# Lindfield Learning Village Modification 2

State Significant Development Modification Assessment  
(SSD 8114 MOD 2)

March 2021

**Figure 3 | Approved Landscape design Part 1 (Source: Stamped Plans 2020)**

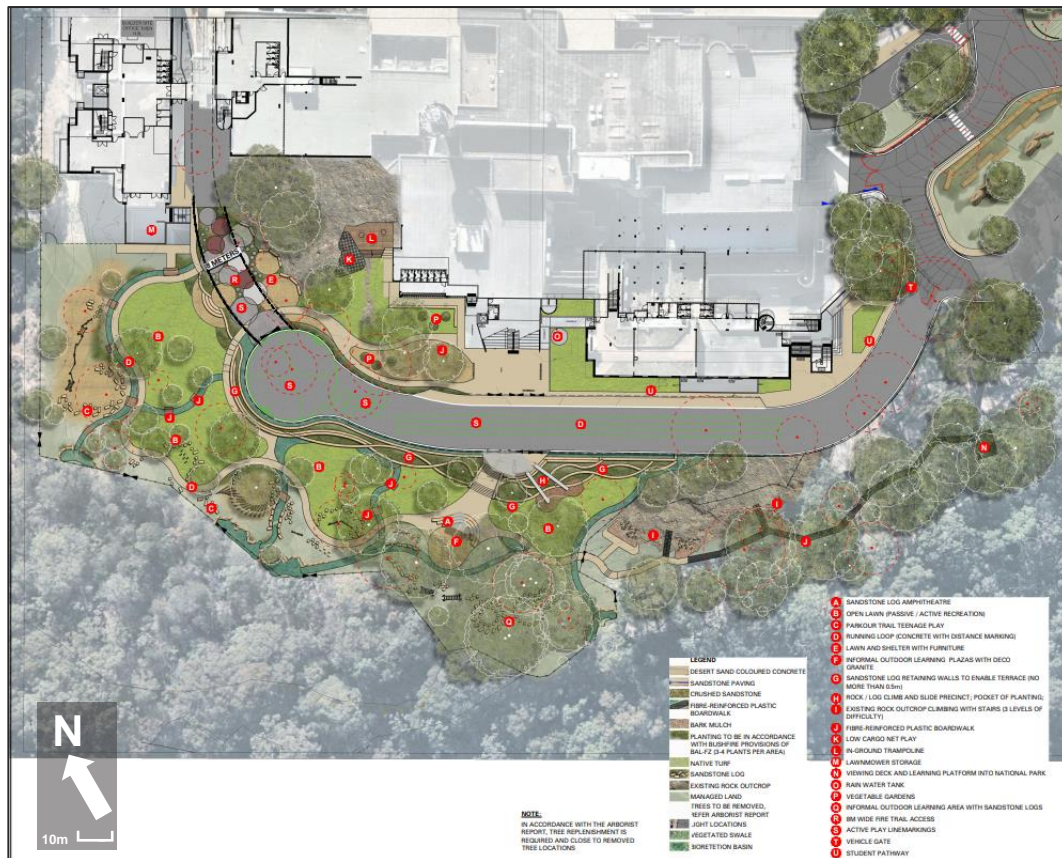
The modification application seeks to make a number of amendments and revisions to the approved landscaping design. The landscaping amendments (as detailed in **Section 2** and **Figures 3 to 6**) are the result of ongoing detailed design of the development, stakeholder engagement and buildability inputs. Broadly the modifications seek to provide better amenity, access and safety outcomes in addition to using materials and finishes that result in better heritage and urban design outcomes.

The Department considers that the proposal is acceptable given that the modifications, seek to retain the overall design intent, appearance and scale of landscaping and public domain interfaces. The proposed modifications are not considered to detrimentally impact or substantially deviate from the originally approved design intent and would ensure that student safety is increased through the removal of potentially hazardous play equipment/design elements.
